**TOWN OF NEWBURGH  
PLANNING BOARD  
TECHNICAL REVIEW COMMENTS**

**PROJECT: BELL-PELELLA 2 LOT SUBDIVISION**  
**PROJECT NO.: 16-02**  
**PROJECT LOCATION: SECTION 8, BLOCK 1, LOT 4.22**  
**PROJECT ZONE: AR**  
**REVIEW DATE: 28 JANUARY 2016**  
**MEETING DATE: 4 FEBRUARY 2016**  
**PROJECT REPRESENTATIVE: SPARACCO & YOUNGBLOOD, PLLC**

PRELIMINARY SUBDIVISION PLAT FOR BELL / PELELLA  
 LOCATED IN TOWN OF NEWBURGH, ORANGE COUNTY, NEW YORK

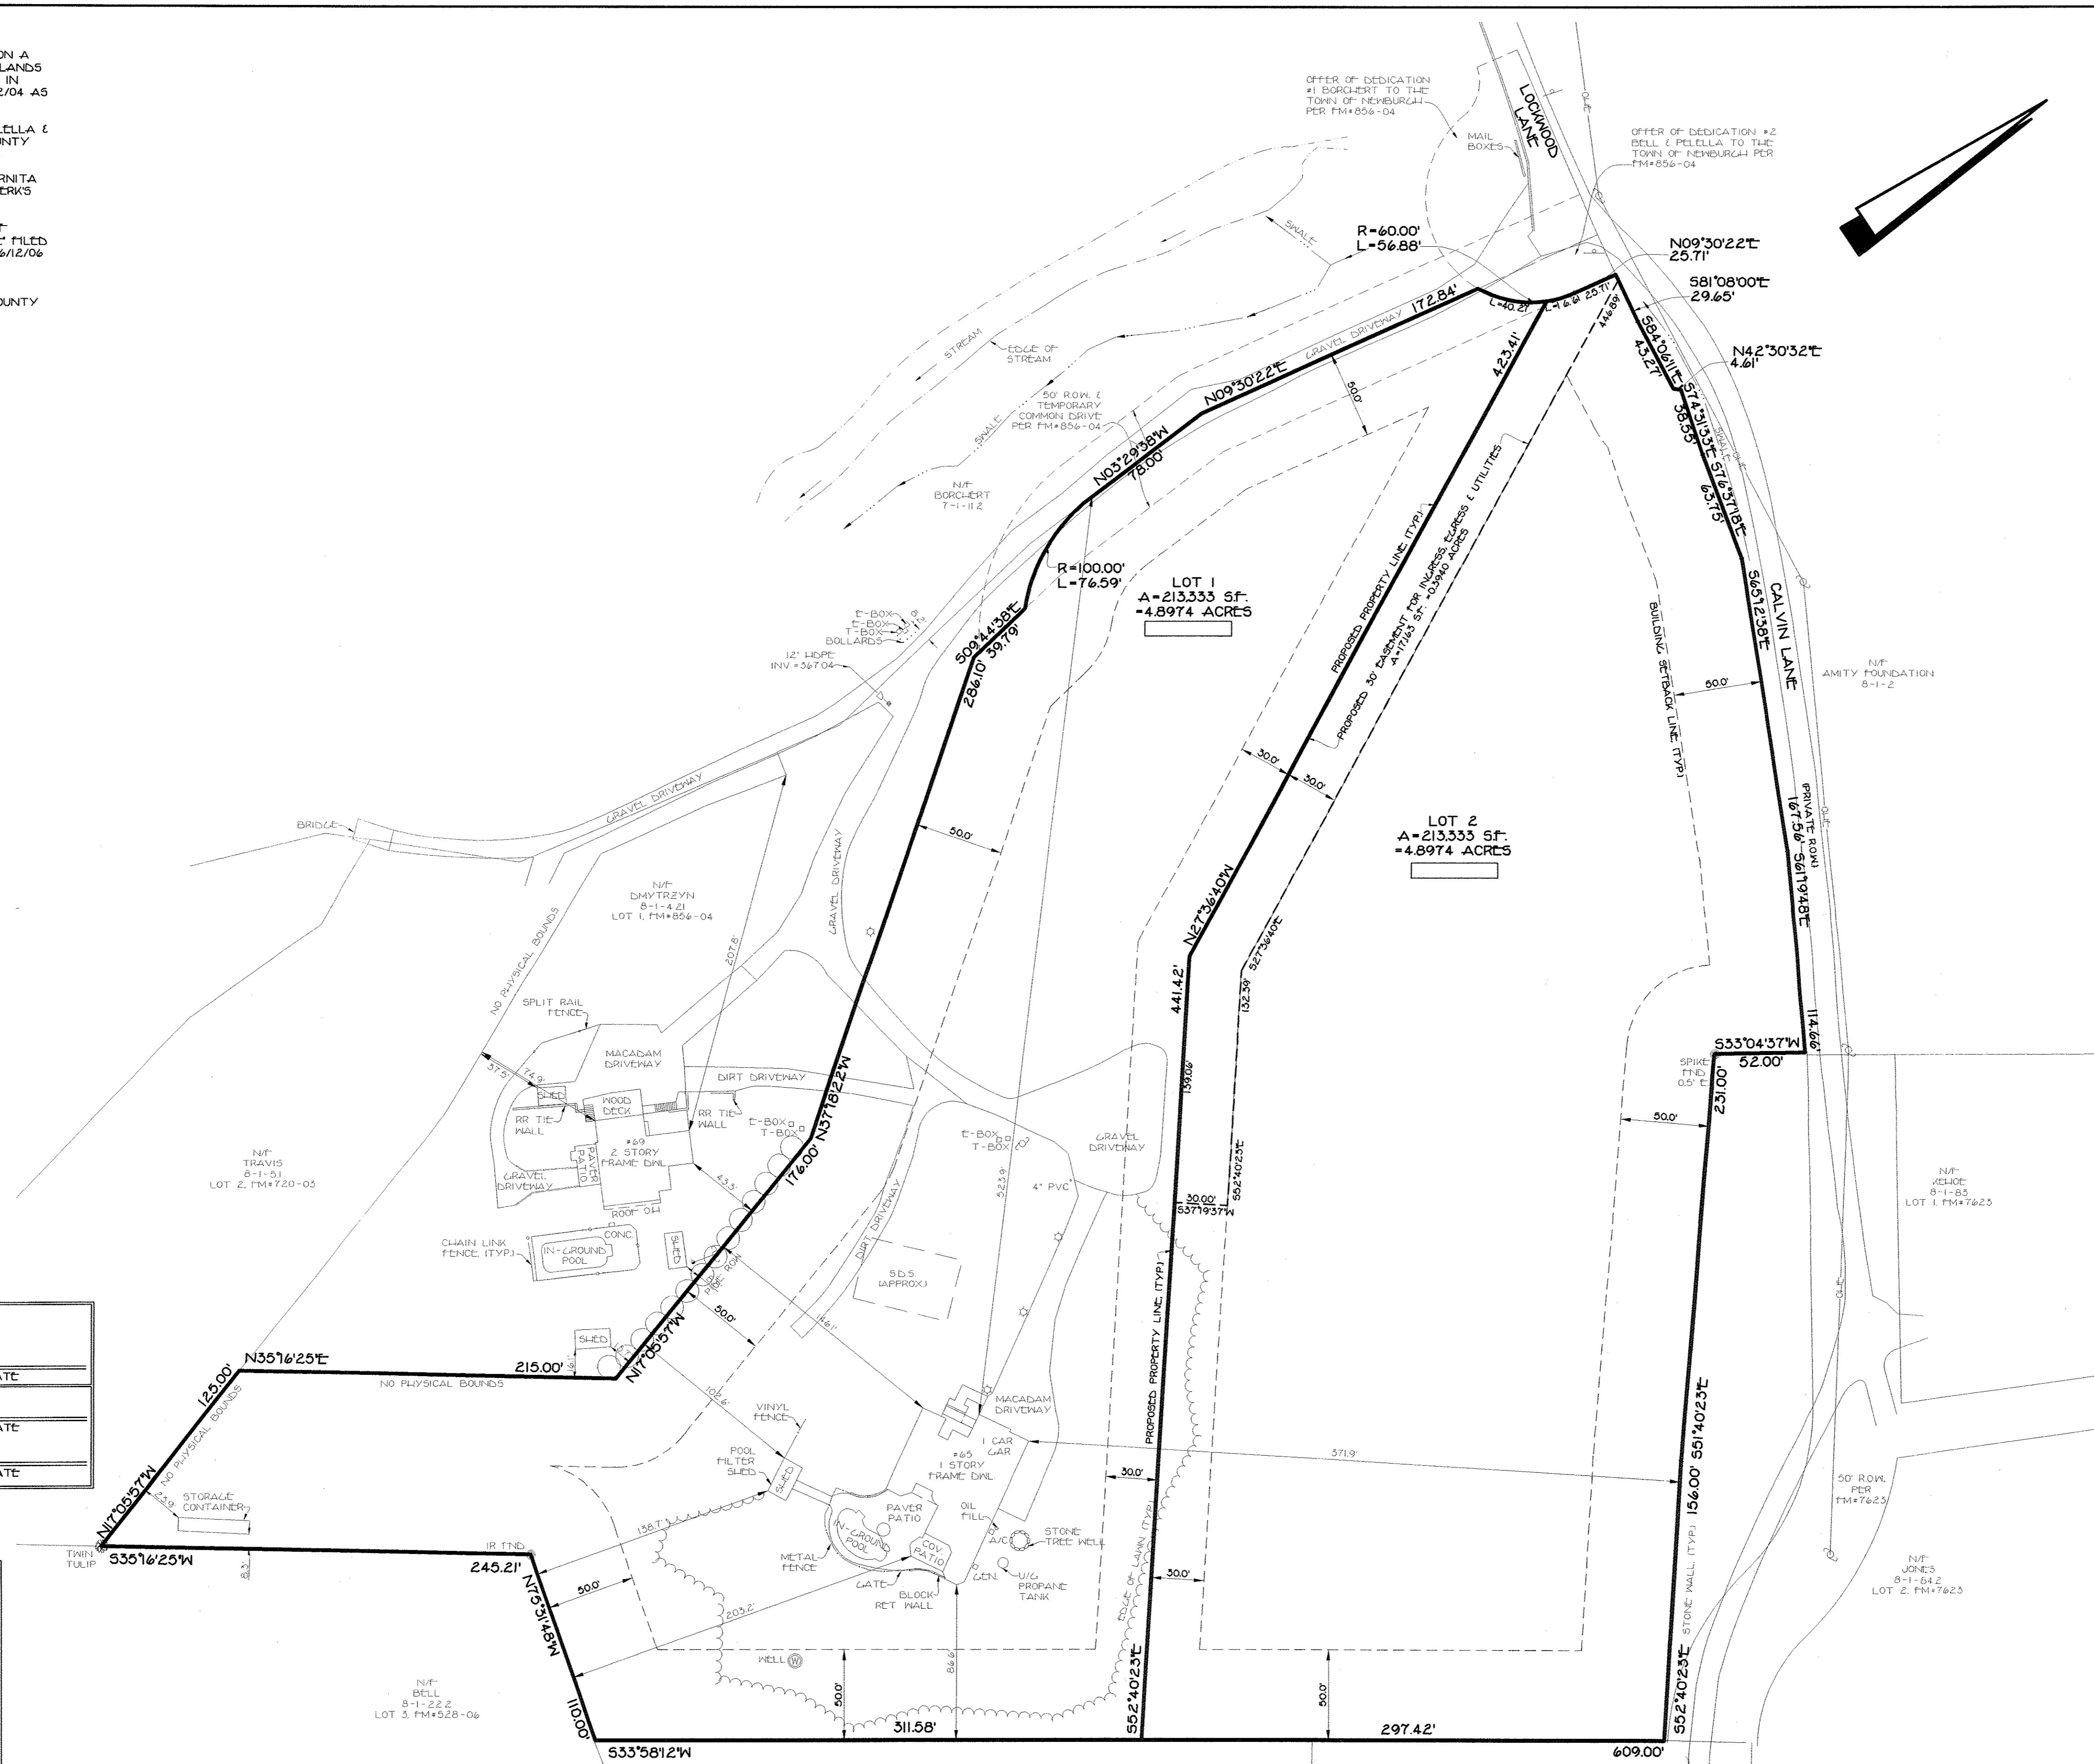
5. Detail of the proposed well should be added to the plans consistent with Health Department Standards.
6. Sheet 1 in a Resolution Block identifies the Town of Blooming Grove.

SY-1125  
 NOV. 2, 2015  
 AS NOTED  
 5 OF 5

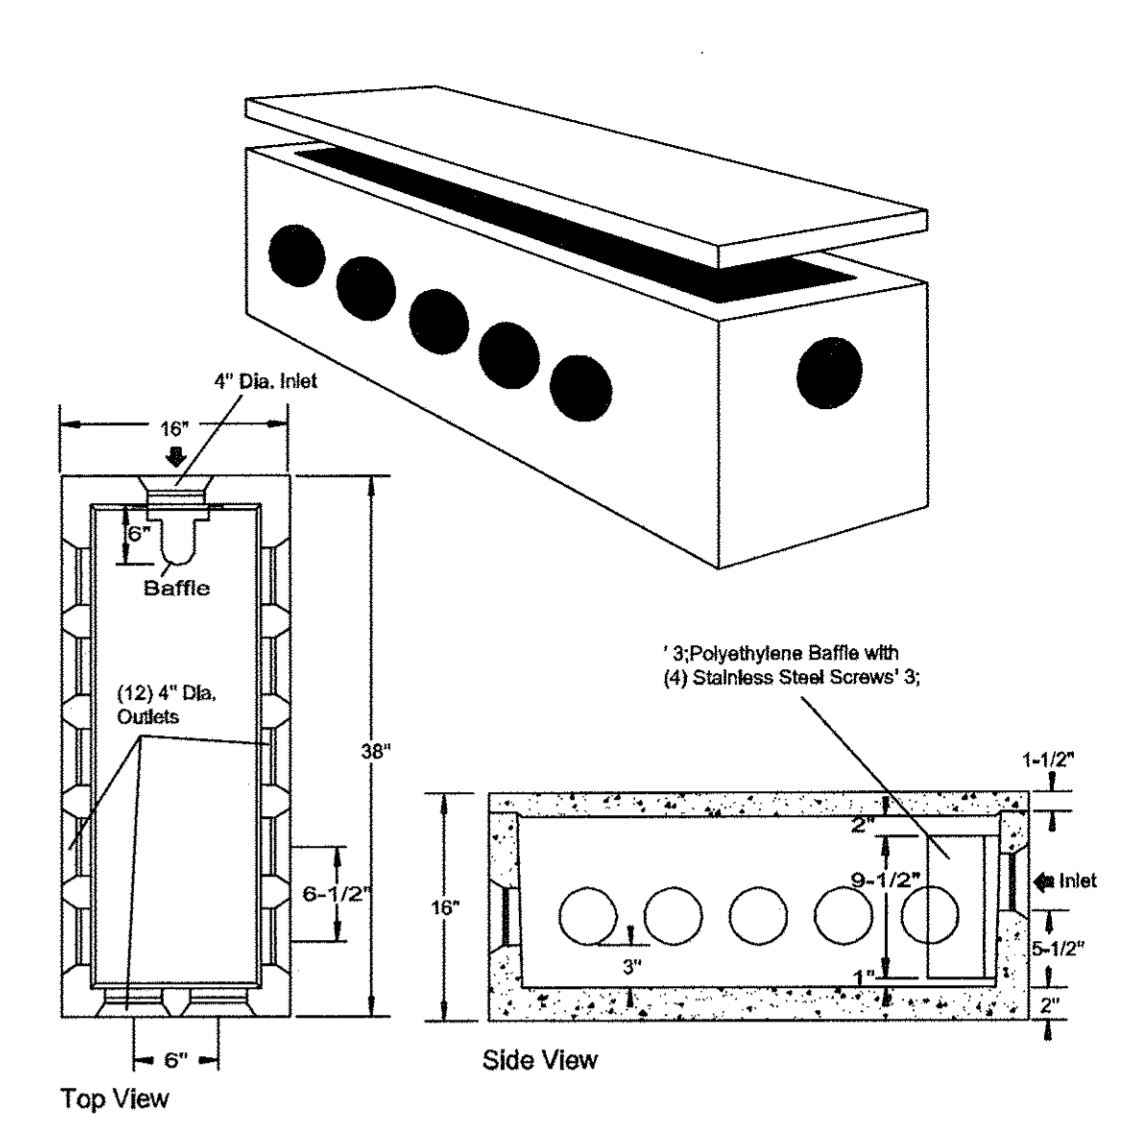
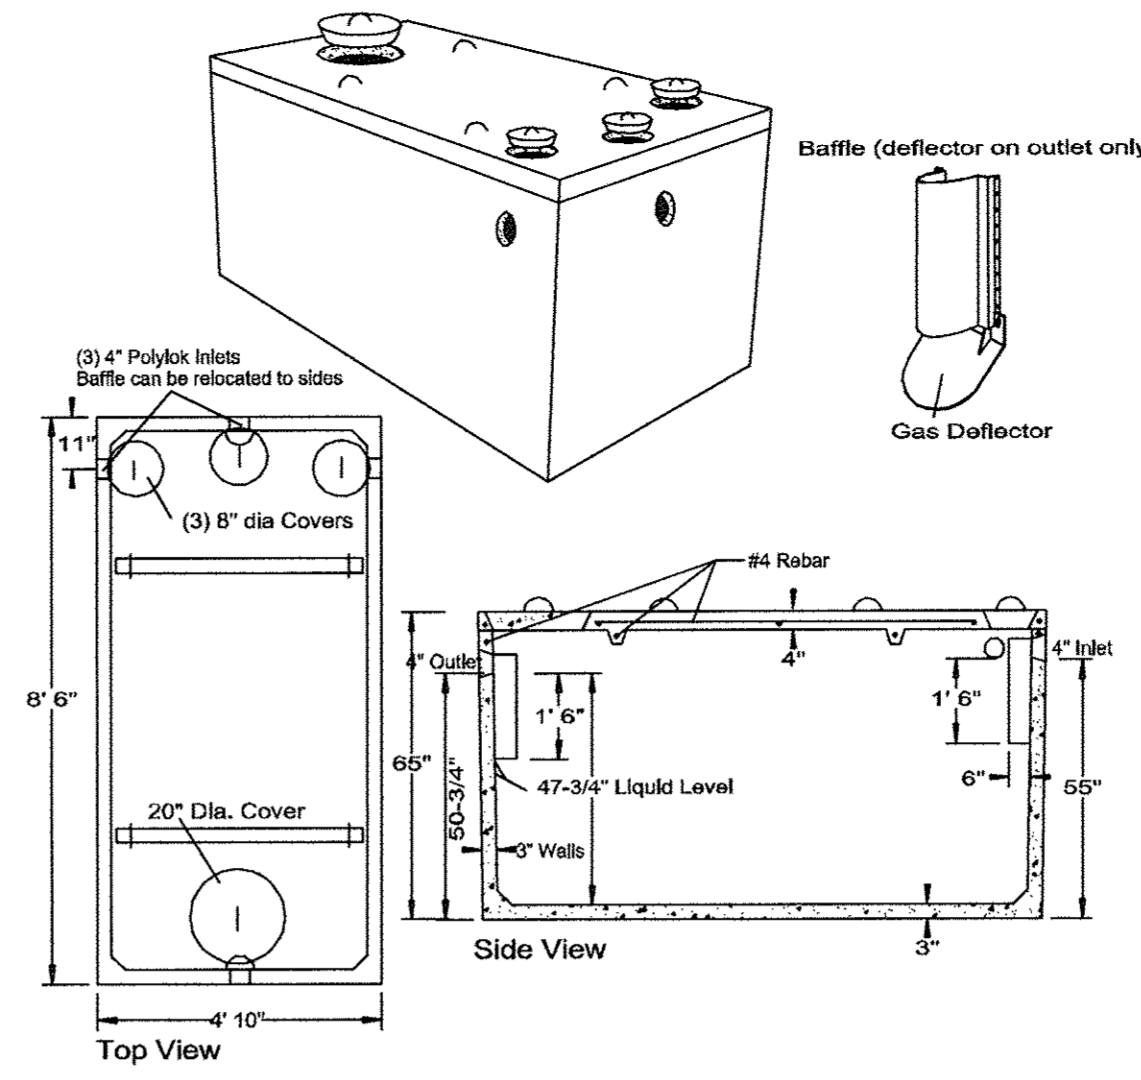
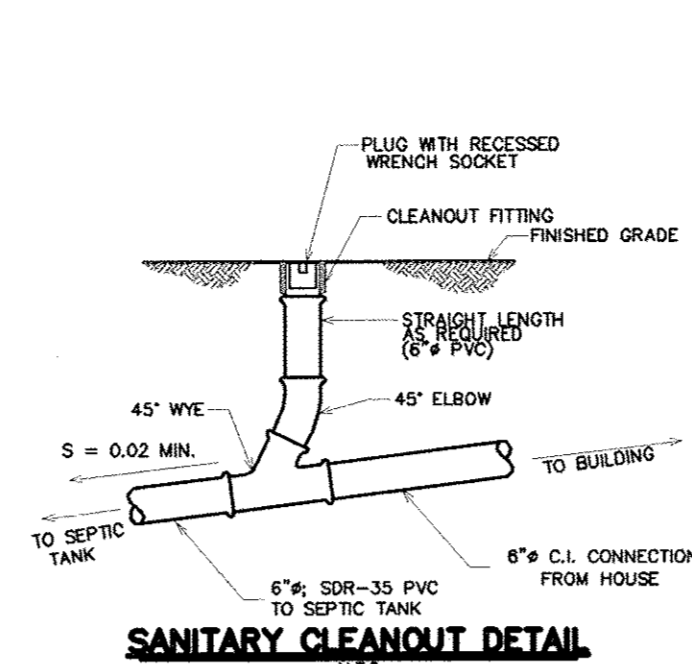
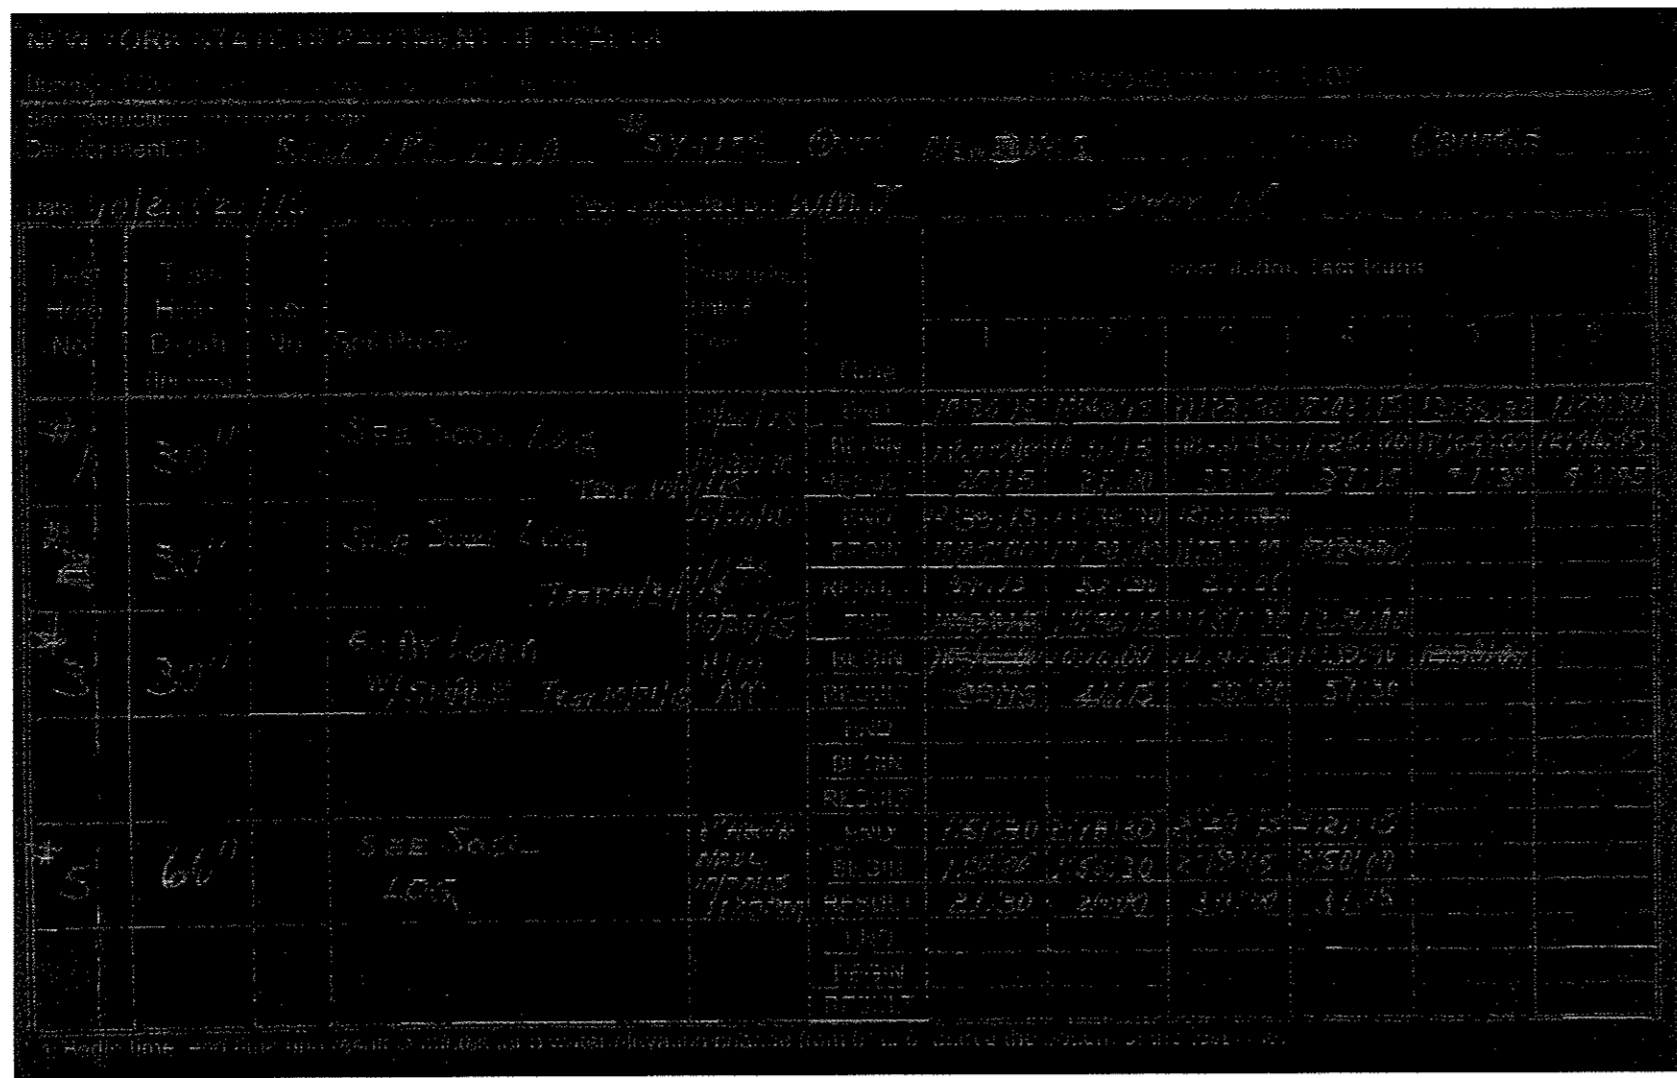
3. Percolation test results on Sheet 5 of 5 are illegible due to the reproduction of the mapping.
4. Septic design identifies septic laterals which are different sizes. Septic system laterals should be equal length to assure equal distribution of effluent throughout the laterals.
